MODIFICATION REQUEST:

41-45 Hill Road, Wentworth Point

***MP06_0098 MOD 2 – Modifications to
increase height and floor space***

Secretary's
Environmental Assessment Report
Section 75W of the
Environmental Planning and Assessment Act 1979
June 2014

Figure 6: Proposed Concept Plan Section

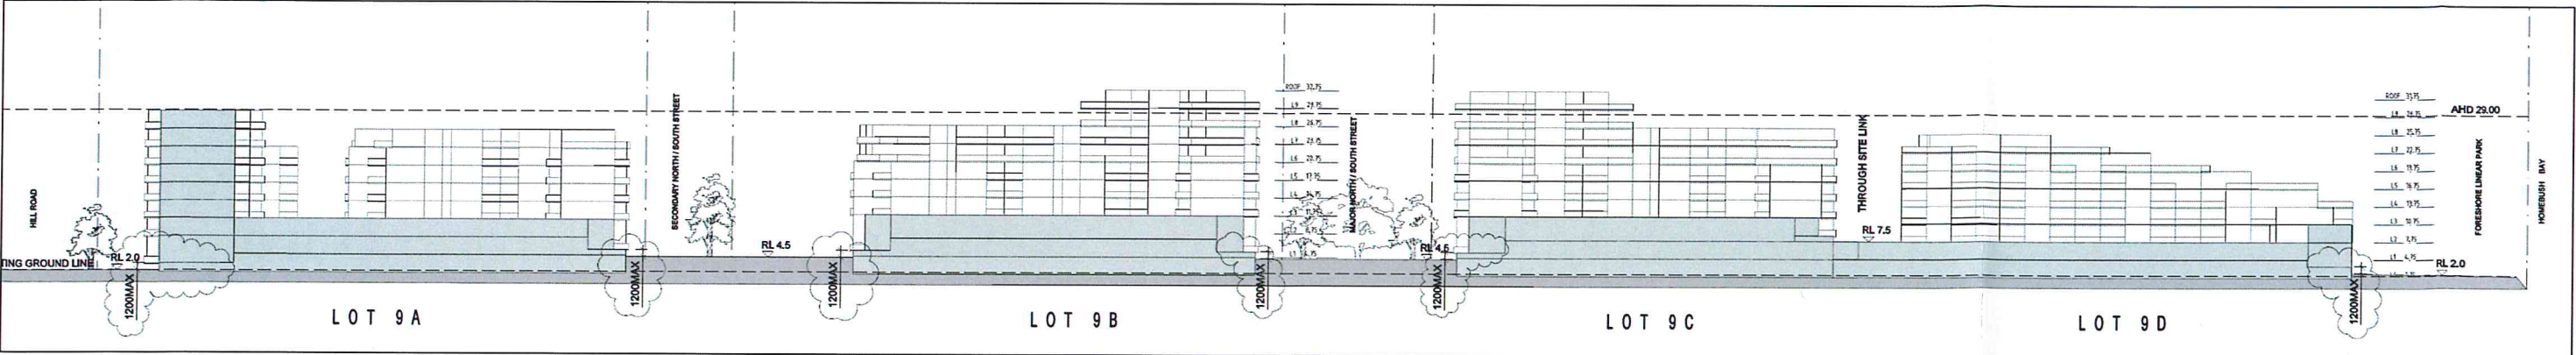
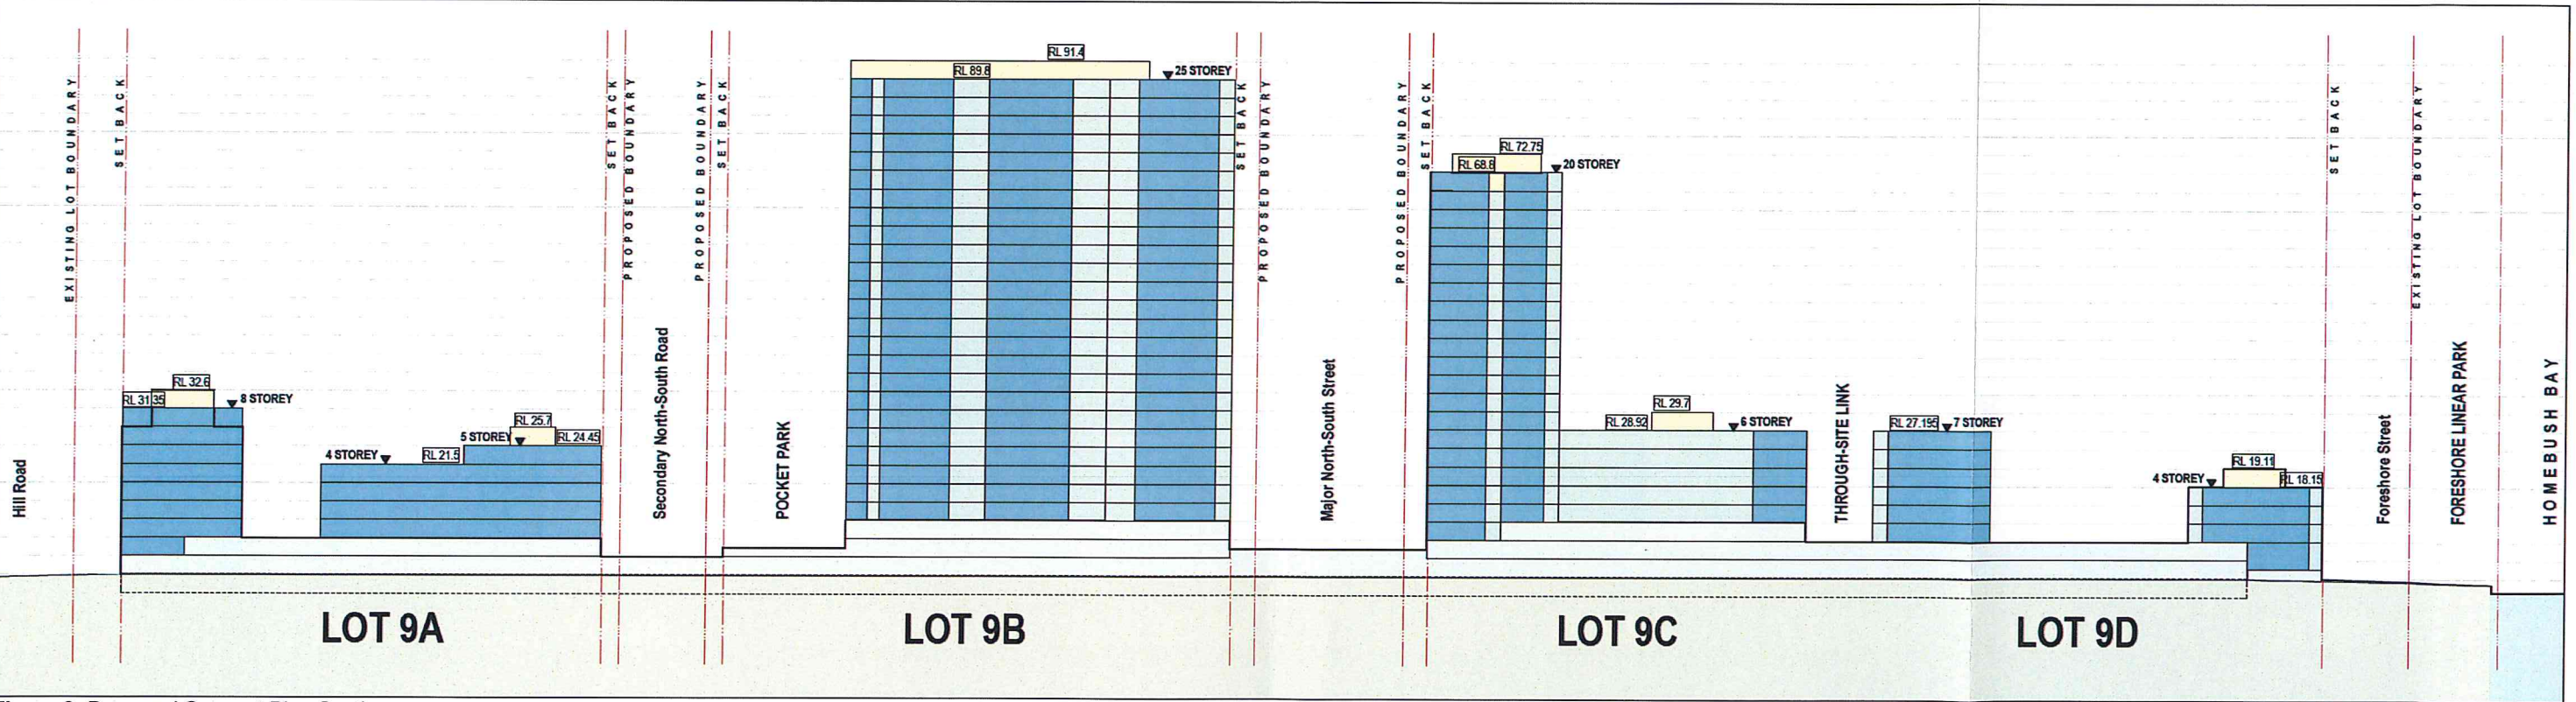
- (a) amend the building envelopes of Blocks 9B (from a maximum of 8 to a maximum of 25 storeys) and 9C (from a maximum of 8 to a maximum of 20 storeys) to reflect the envelopes of the HBW DCP;

A comparison of the building envelope heights is provided at **Figures 5 and 6**.

It is proposed to amend building layouts and increase building heights on Blocks 9B and 9C. The primary change is the introduction of 2 high rise towers, being a 25 storey tower on Block 9B and 20 storey tower on Block 9C, representing a significant increase in height from the Concept Approval which provides a maximum of 8 storeys on each block. No changes are proposed to Blocks 9A and 9D which will remain as previously approved.

Figure 7: Proposed Plans

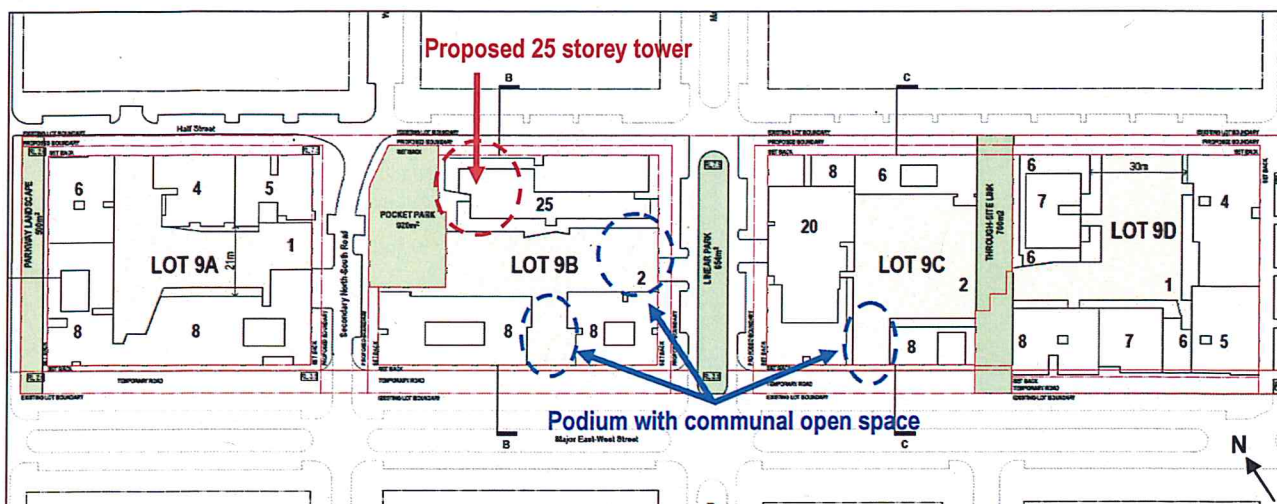
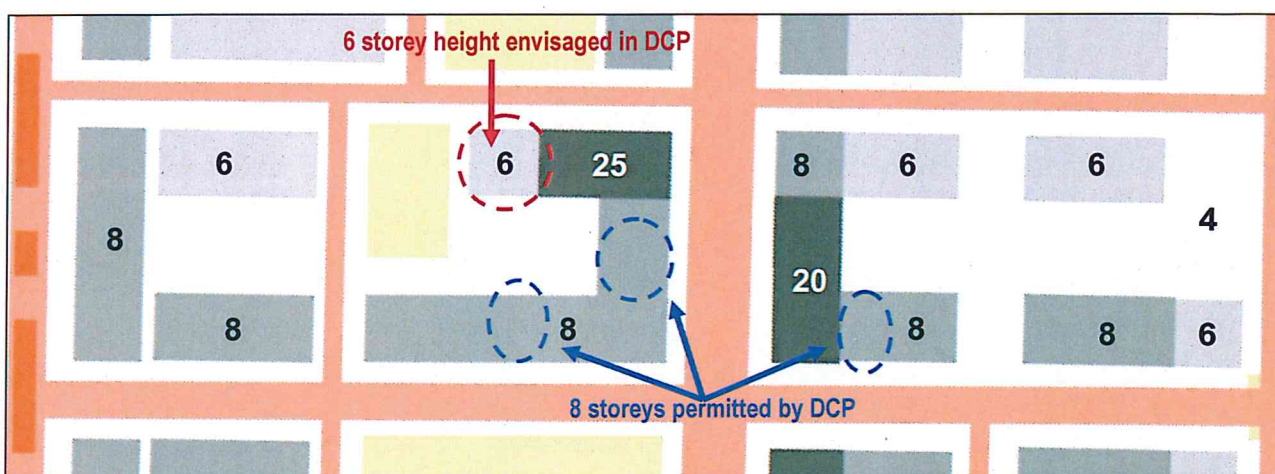
The proposed building envelopes in Blocks 9B and 9C are generally consistent with the envelopes and maximum building heights depicted in the HBW DCP, with the exception of the north-western portion of Block 9B. The DCP indicates a maximum height of 6 storeys for the north-western portion of the building (adjacent to the pocket park), however the proposal provides a 25 storey height for the entire length of the tower, as shown in red in **Figures 7 and 8**. At the same time other parts of Blocks 9B and 9C would not include development above the podium level, where HBW DCP would permit a height of 8 storeys as shown in blue in **Figures 7 and 8**.

The additional height and building massing in the north-western portion of Block 9B is therefore offset by reduced heights and massing in other sections of the Blocks 9B and 9C. Further, permitted increases in heights in Blocks 9A and 9D under Amendment 1 to HBW DCP are not being utilised as those blocks are currently under construction and will remain as previously approved by Council.

The department considers that the adjustments to the building envelopes, including the provision of 25 storeys adjacent to the pocket park is acceptable in this case as:

- the incorporation of breaks in building massing to provide podium level communal open space improves site permeability and reduces the appearance of building massing, improving the visual impacts of the development at street level;

- HBW DCP envisages towers being located immediately adjacent to open space in other locations (refer to **Figure 4**).
- the 25 storey tower is proposed to be located to the south-east of the park, and would result in no additional overshadowing impacts to the park as compared to a 6 storey element;

- the floor plate of the tower remains below the maximum of 950m² floor area, as required by the DCP to ensure tall and slender forms and to avoid monolithic buildings;

- no material view impacts arise from the increased height at this location, noting the location and height of other towers in the area; and
- the tower would be capable of providing a suitable visual interface with the park, subject to appropriate façade treatments to ensure the perception of a pedestrian scale to the tower as

viewed from within the park. In this regard a modification is recommended to ensure appropriate façade treatments are incorporated in the future DA for the site.
